# Work Order ID 90714

Item Name: Crosstube Fwd

<b>DART AEROSPACE LTD</b>		<b>Work Order:</b>	90714
<b>Description:</b> Crosstube High Fwd (206B)		<b>Part Number:</b>	D206-667-101
<b>Inspection Dwg:</b> D206-667-141	<b>Rev:</b> C	<b>Page 1 of 1</b>

DRAWING NO. D206-667-141	TITLE CROSSTUBE ASS'Y (206B HIGH FWD)	REV. C	<b>DART AEROSPACE LTD ENGINEERING ORDER</b>		D.E.O. NO. D206-667-141-C-1	SHEET NO. SHEET 1 OF 1	SCALE NTS
DRAWN 90	CHECKED ASS	MFG. APPR. 12	APPROVED MD		DE APPR. H		
DATE 11.07.15	DATE 11.07.20	DATE 11.07.21	DATE 11/07/21		DATE 11.07.21

**DETAIL P**  
BONDING STRAP INSTALLATION 2 PL

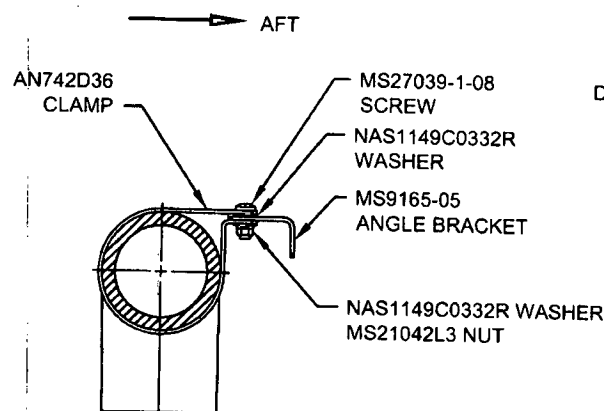
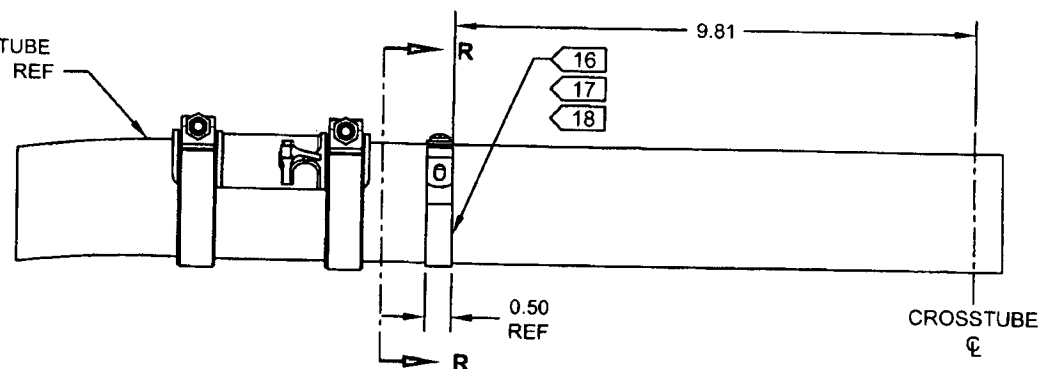
ADD ELECTRICAL GROUNDING STRAP

ADD

ITEM	QTY -141	PART NUMBER	DESCRIPTION
1	X	D206-667-141	CROSSTUBE ASSEMBLY (206B HIGH FWD)
10	2	AN742D36	CLAMP
11	2	MS9165-05	ANGLE BRACKET
12	2	MS21042L3	NUT (OR MS21042-3)
13	2	MS27039-1-08	SCREW
14	4	NAS1149C0332R	WASHER (OR AN960C10L)
